Restraint Equipment

AD/RES/12 Safety Harness Buckle - Pacific Scientific Rotary 8/93 Amdt 1

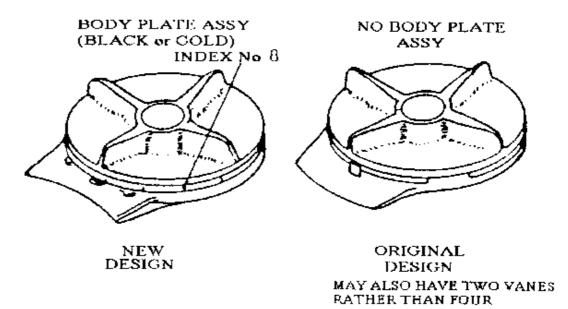
- 1. Inspect to determine if rotary buckle assembly contains a gold or black body plate assembly as identified in Figure 1.
- 2. For those restraint systems incorporating Pacific Scientific rotary buckles without a gold or black body plate assembly as specified in Figure 1 of this AD:
 - (a) Substitute any approved restraint system not incorporating the above described rotary buckle; or
 - (b) Replace the buckle element of the restraint system with a Pacific Scientific buckle element incorporating a gold or black body plate assembly as identified in Figure 1 of this AD.
